**EASTSOUND SEWER AND WATER DISTRICT
WASTEWATER TREATMENT PLANT UPGRADE – PHASE 2**

**ADDENDUM NO. 3 (22 pages total)
Issue Date: March 11, 2025**

DESIGNED BY	JCC	DRAWN BY	MCS	CHECKED BY	AWL
EASTSOUND SEWER AND WATER DISTRICT					
SAN JUAN COUNTY					
WASHINGTON					
WASTEWATER TREATMENT PLANT UPGRADE - PHASE 2					
TRAIN 1 PLAN					
DATE	3-4-2025	SCALE	AS SHOWN	JOB NUMBER	2023-123
SHEET	C3.1	PAGE	29	OF	91

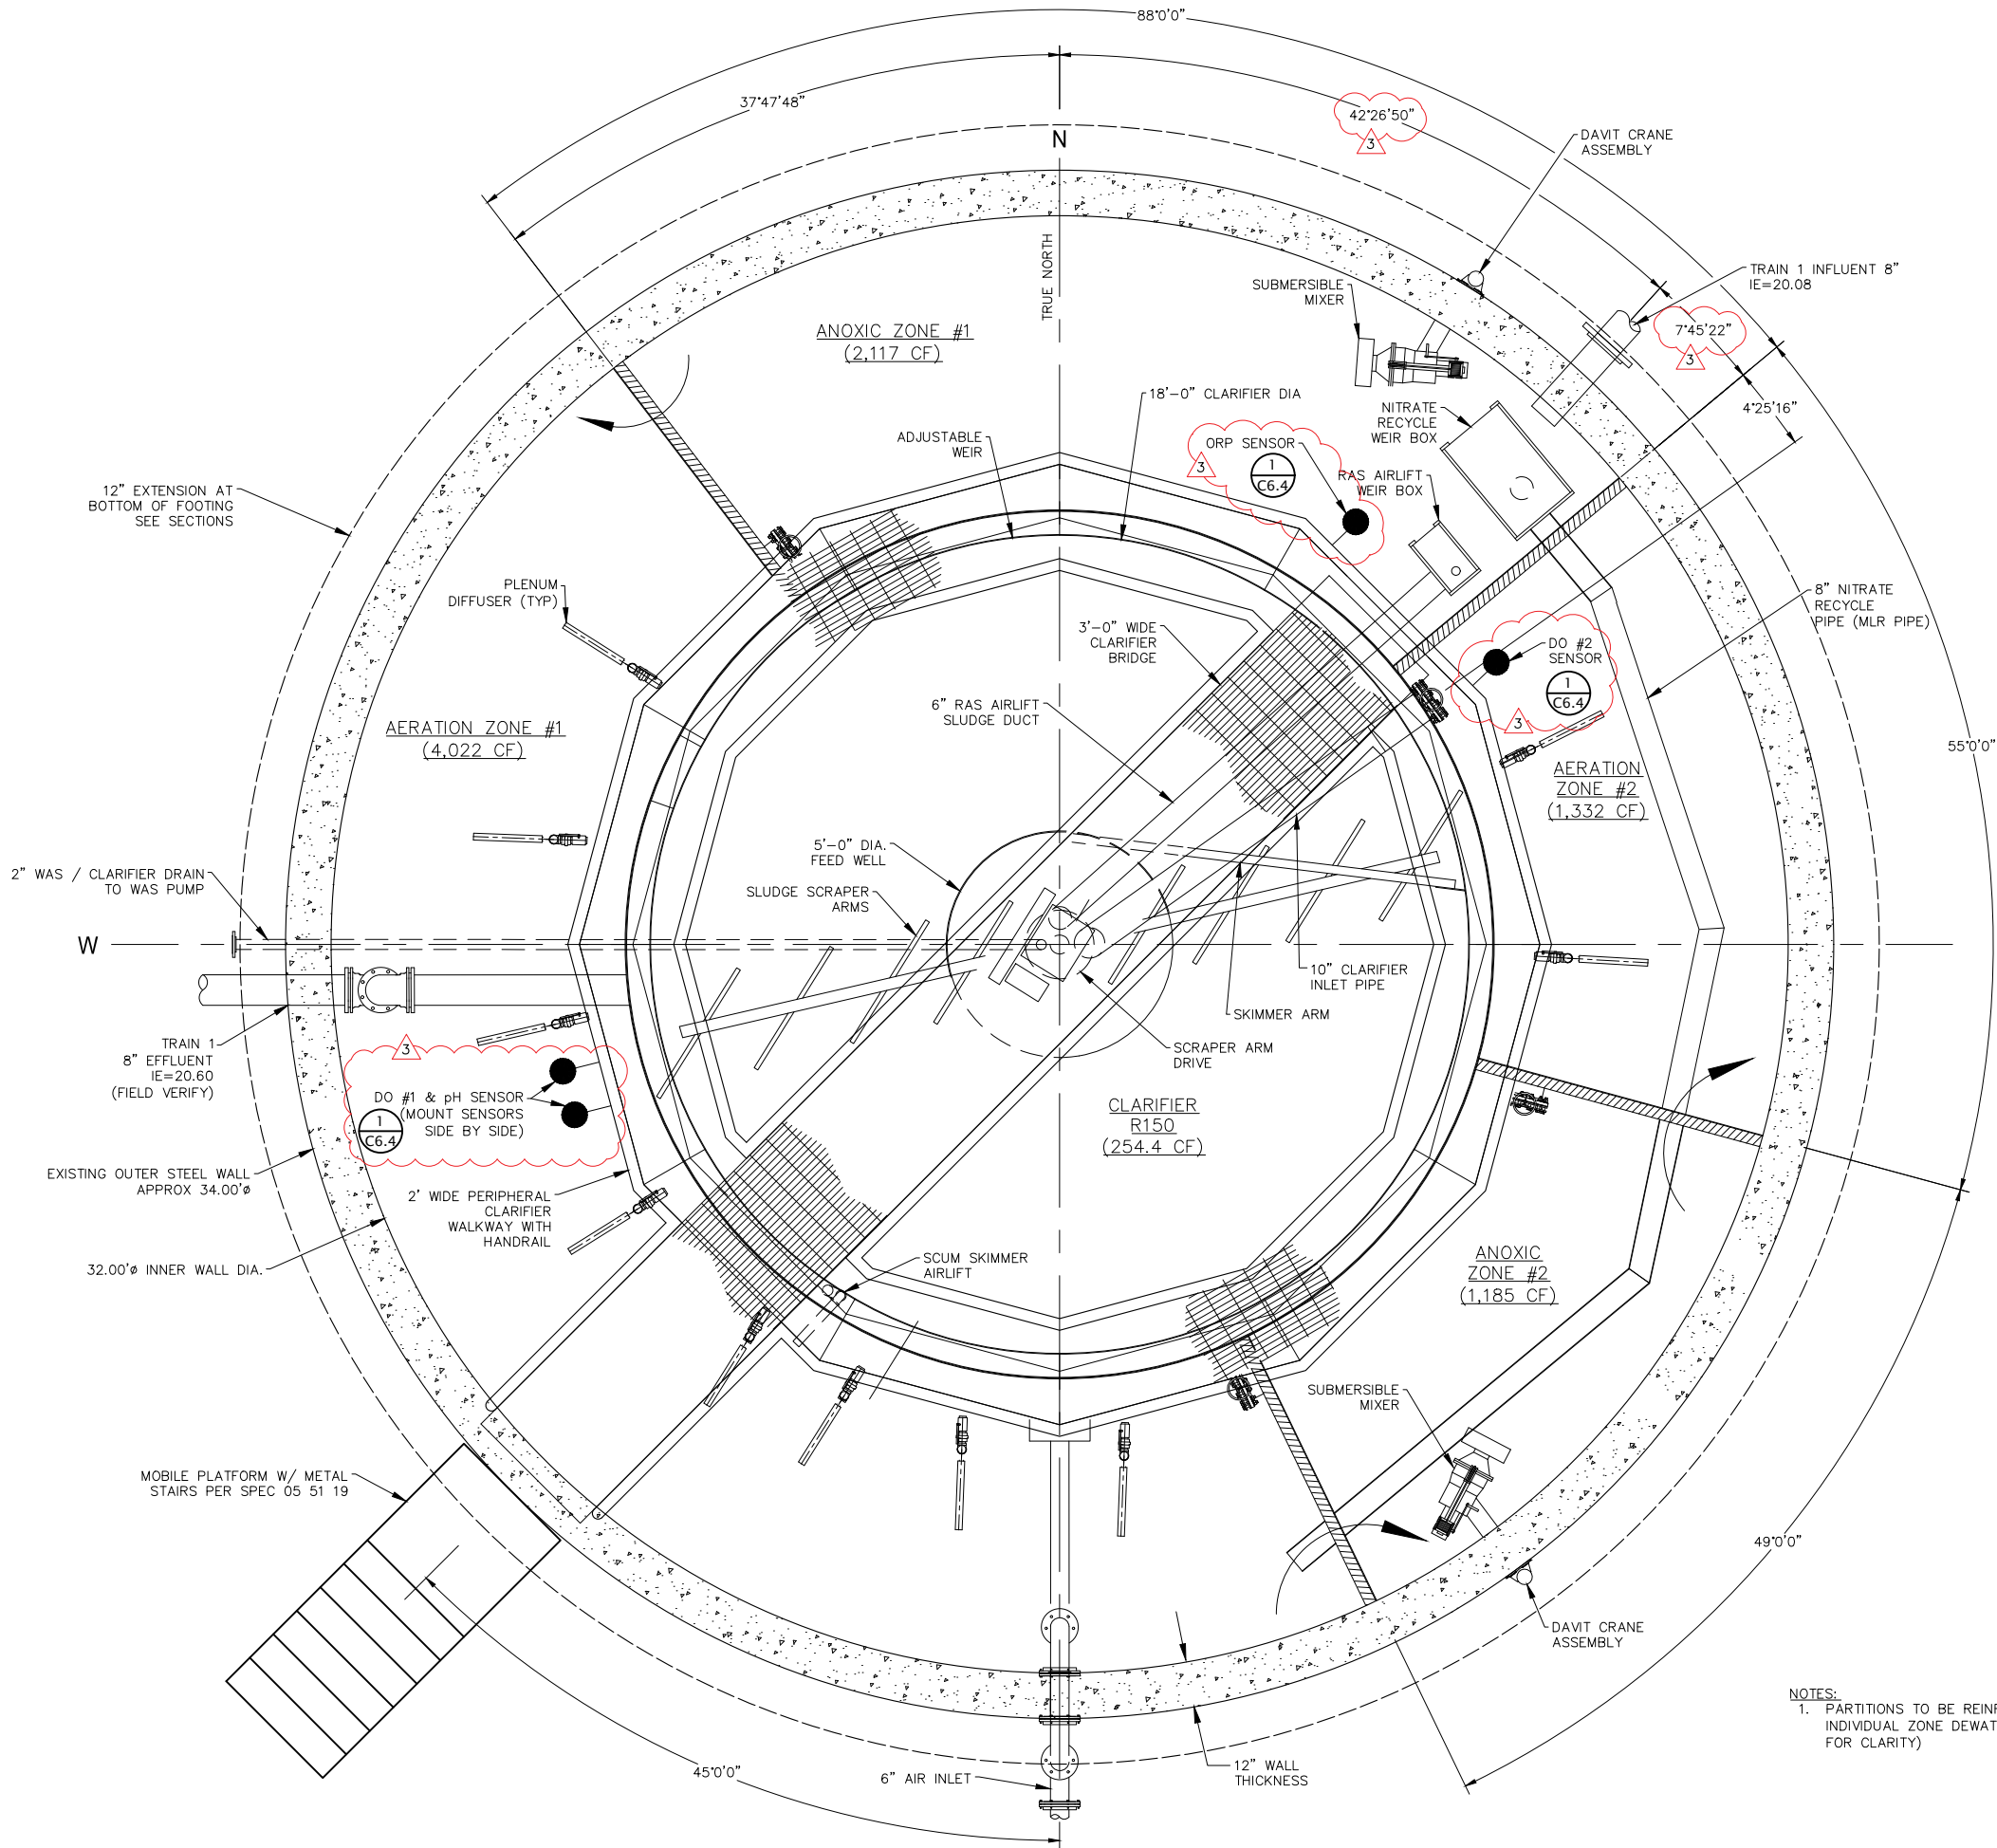
- The DO & pH sensors are to be individual sensors mounted side by side, as shown.
- The DO sensor in Aeration Zone #2 has been relocated to the end of the basin.
- An ORP sensor has been added to the front of Anoxic Zone #1.
- The inlet pipe alignment has been slightly adjusted to match Train 2.

C3.4

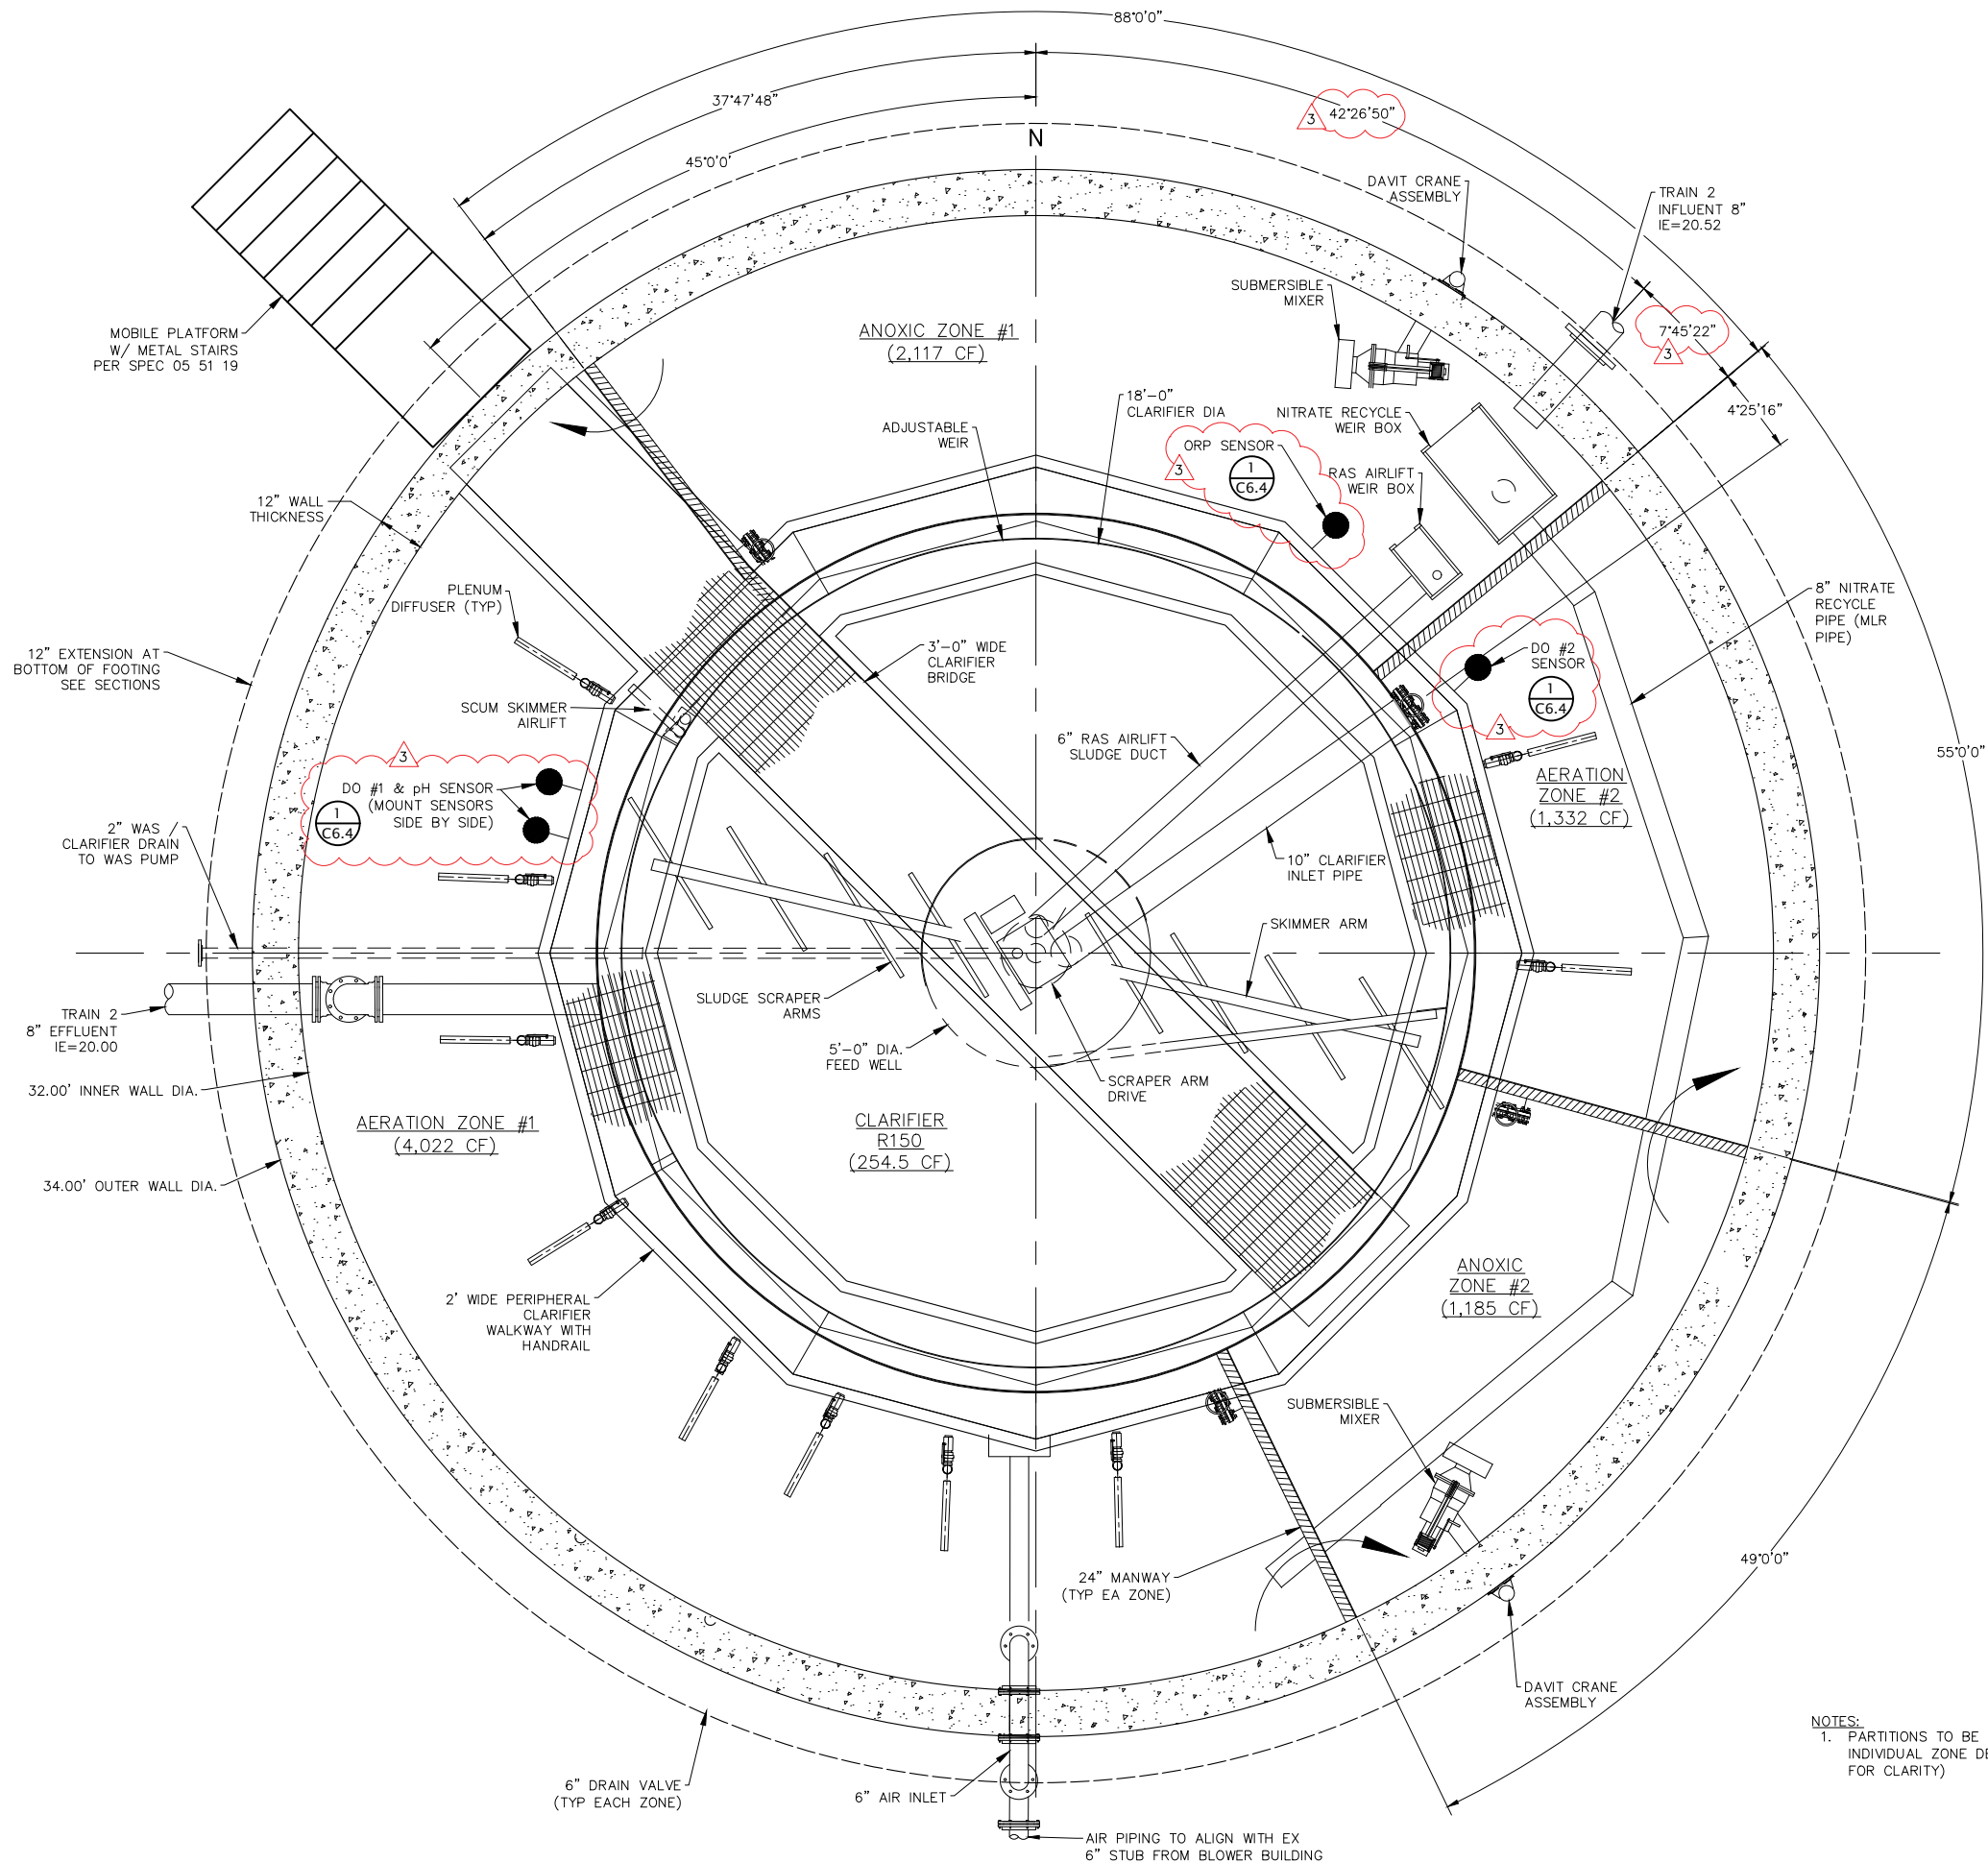
- The DO & pH sensors are to be individual sensors mounted side by side, as shown.
- The DO sensor in Aeration Zone #2 has been relocated to the end of the basin.
- An ORP sensor has been added to the front of Anoxic Zone #1.
- The inlet pipe alignment has been slightly adjusted to match Train 1.

SHEET	C3.6	DATE	3-4-2025
PAGE	34 OF 91	SCALE	AS SHOWN
		JOB NUMBER	2023-123

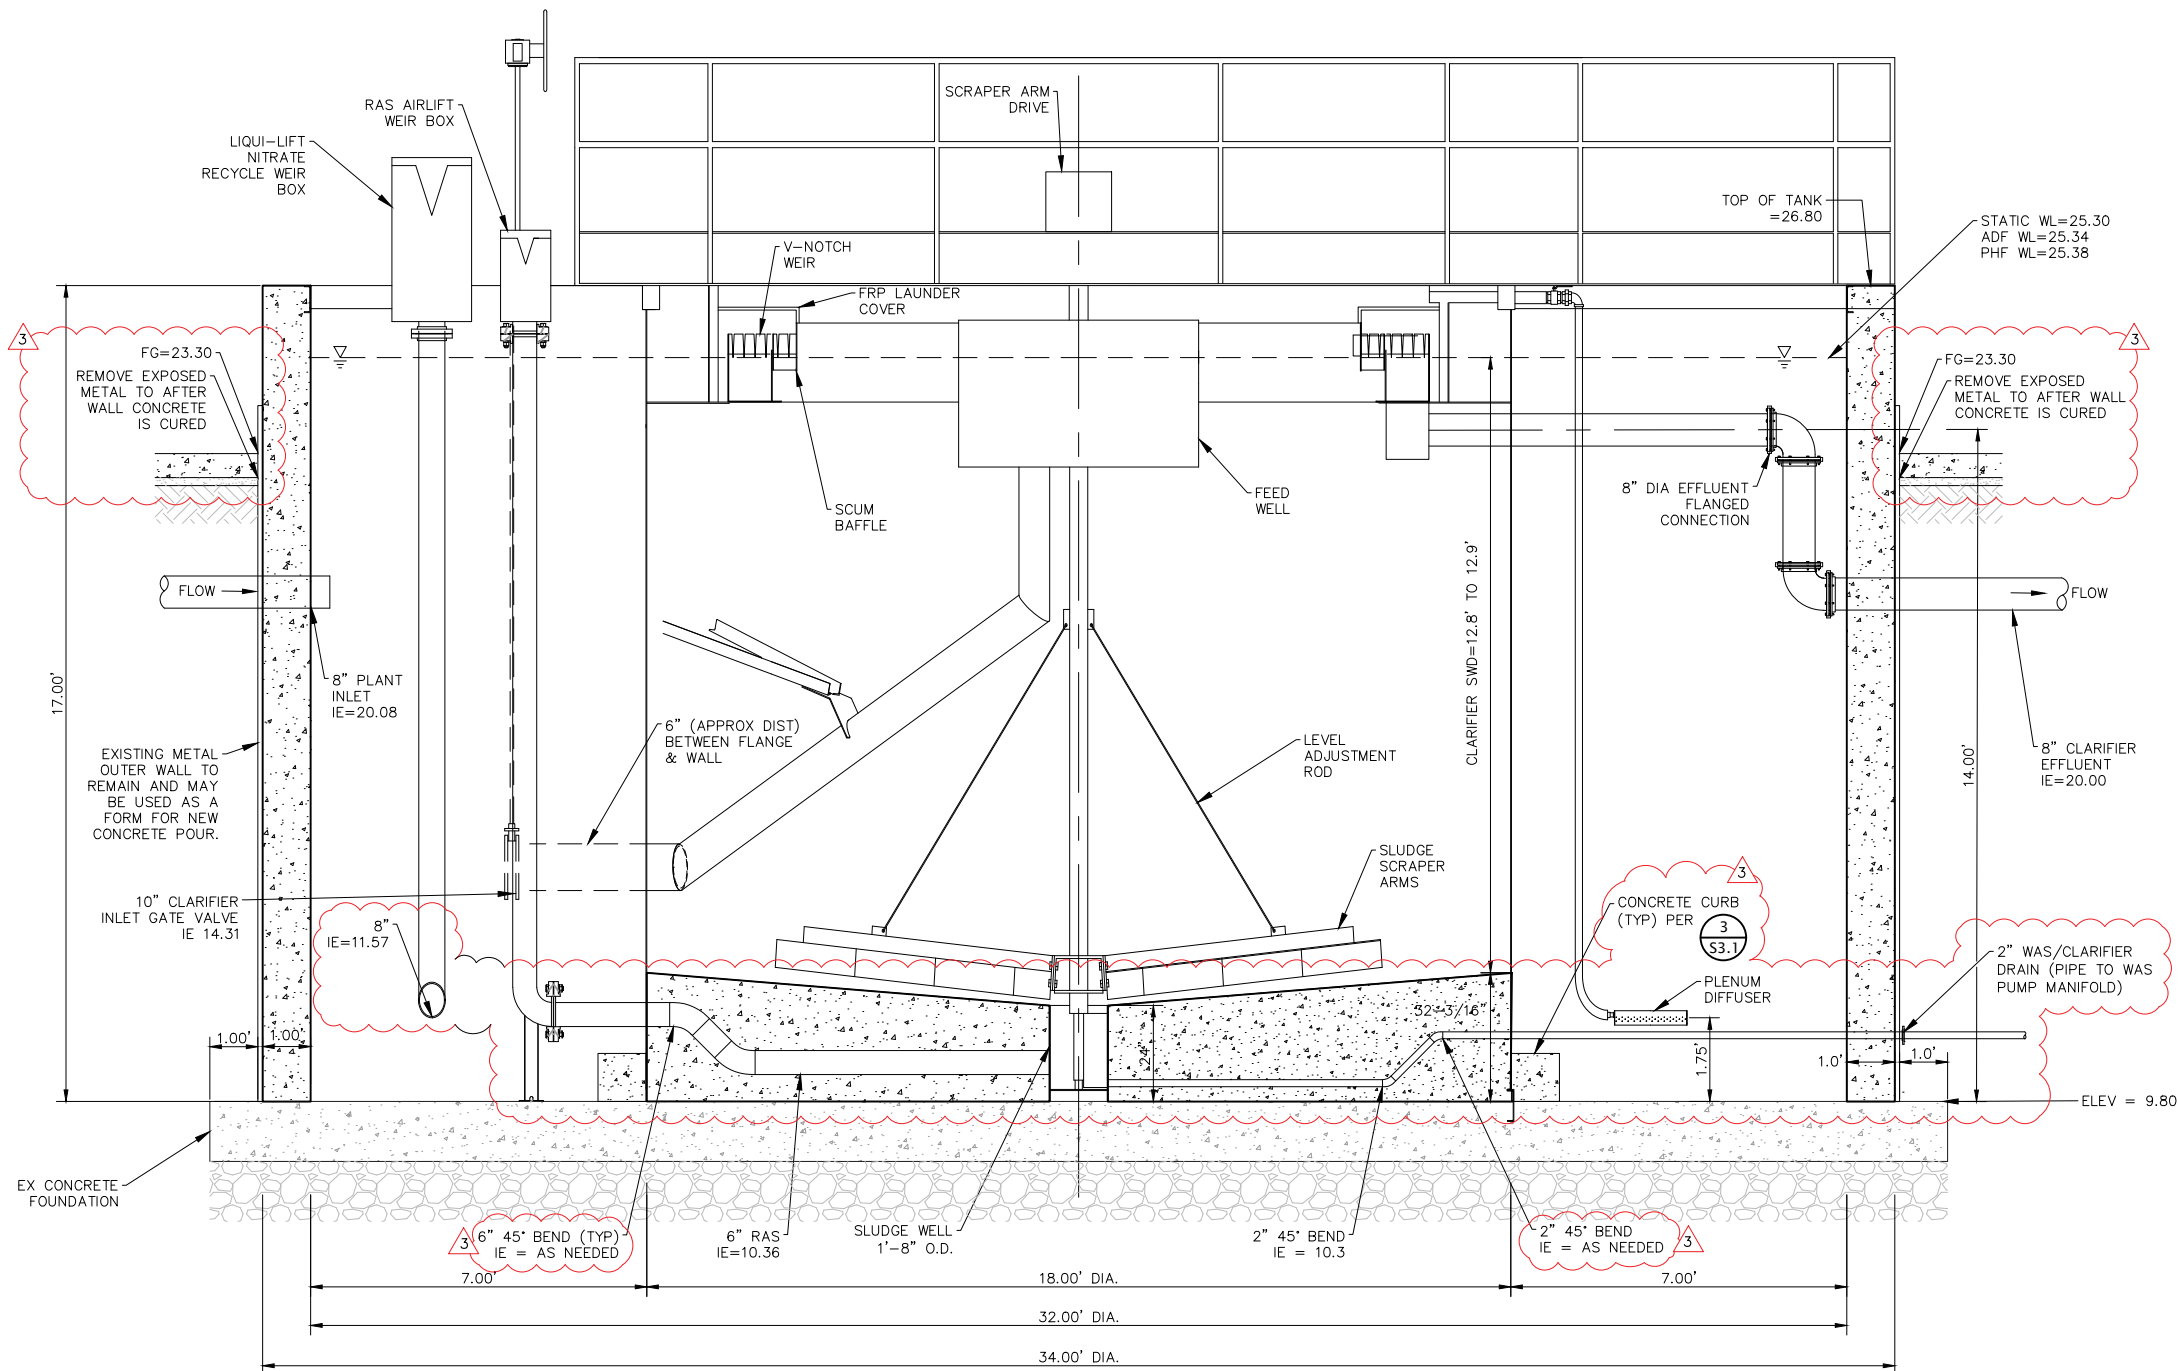
- New concrete curbs for partition embedment added.
- (2) 45-degree bends each added to RAS and WAS piping to raise IE 1.0-ft to avoid conflict with newly proposed concrete curbs.
